**SUBJECT: CONDITIONAL USE PERMIT APPLICATION NO. P18-03987 FOR PROPERTY
LOCATED AT 293 W BEECHWOOD AVE (APN: 30315201)**

The Fresno Planning Commission, on September 18, 2019, approved Conditional Use Permit Application No. P18-03987, which was filed by Mike deAlba, DeAlba Architecture, on behalf of Star Housing Project, Inc., and pertains to 0.24 acre of property located at 293 West Beechwood Avenue in the Pinedale Neighborhood Community bounded by West Herndon, North Ingram, West Alluvial, and North Blackstone Avenues. The applicant proposes the construction of a market rate 2-unit detached multiple family residential townhouse development on property zoned RS-5/EA (Residential Single Family, Medium Density/Expressway Area Overlay). The proposed project was determined to be exempt from the California Environmental Quality Act by the Planning and Development Department on August 5, 2019 through a Class 32 Categorical Exemption.

SUBJECT: Conditions of Approval for **P18-03987**

SP-1

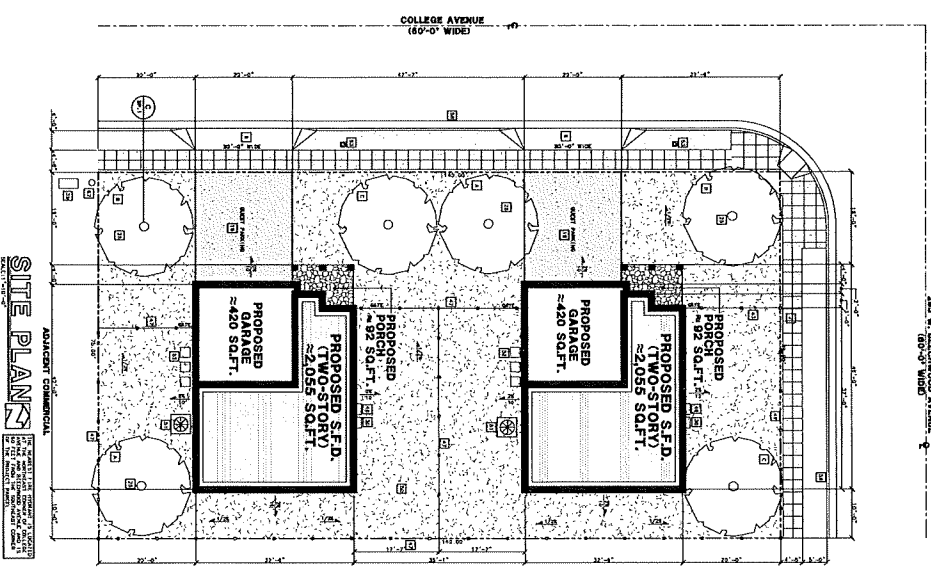
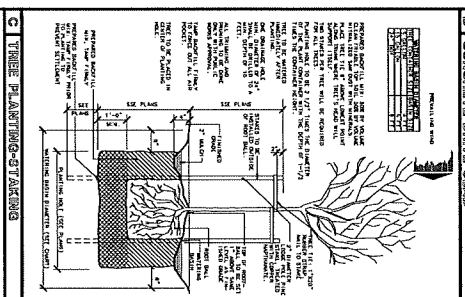
ATTENTION:	
Prior to resubmitting the corrected exhibit, provide the following information on the site plan:	
A. <u>GENERAL REQUIREMENTS</u>	1. Identify all <u>property lines, and proposed Lot Merger.</u>

B. <u>OFFSITE INFORMATION:</u>	1. Clearly identify existing and proposed <u>curb, gutter, sidewalks</u> (provide width), <u>accessibility ramps</u> (provide radius), <u>boxes, etc.</u> 2. Identify the required <u>4' minimum path of travel</u> behind ramp adjacent to property. A pedestrian easement may be required if Title 24 requirements cannot be met.

C. <u>ONSITE INFORMATION:</u>	1. Identify a <u>12' visibility triangle</u> at all driveways and points of ingress/egress into public right of way per Fresno Municipal Code (FMC) 15-2018B. 2. Properly identify existing and proposed <u>walls and fences</u> complete with location height and type of material.

D. <u>OTHER IMPORTANT INFORMATION:</u>	Identify if required proposed <u>Parcel Merger.</u> Provide reference number.
